<div>Sheet</div> <div>1(9)</div>					BOMBARDIER	
<div>Author</div> <div>C. Mackie</div>		<div>Issue</div> <div>3</div>	<div>Document number</div> <div>IS580001669A4</div>	<div>Save Date</div> <div>13/01/12</div>	<div>File</div> <div>IS580001669A4-03.doc</div>

Application Note

Modifications to *EBI* Track 200 TI21 Tuning Unit and ETU T1/T2 Connections and Trackside Wiring Recommendations

Photo 1: T1/T2 Termination Arrangement

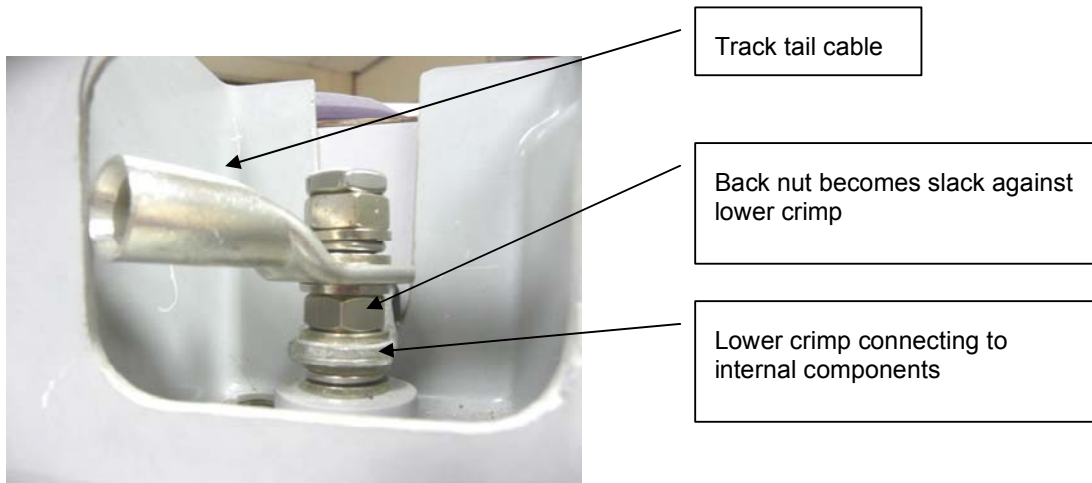
TI21 Tuning Units and ETUs are known to be prone to connection problems at the T1/T2 terminals where the track tails are terminated onto the unit. Investigation has shown that the termination arrangements for the 10mm tail cable crimp can become slack owing to the 'Back nut' becoming loose (see Photo 1). The resulting loose connection causes degradation in performance, often leading to right side failure.

For new build Tuning Units and ETUs, Bombardier have altered the terminal arrangement to remove the 'Back nut' and these units are identified by mod strike as follows:

New build TU with modification = mod strike 3

New build ETU with modification = mod strike 4
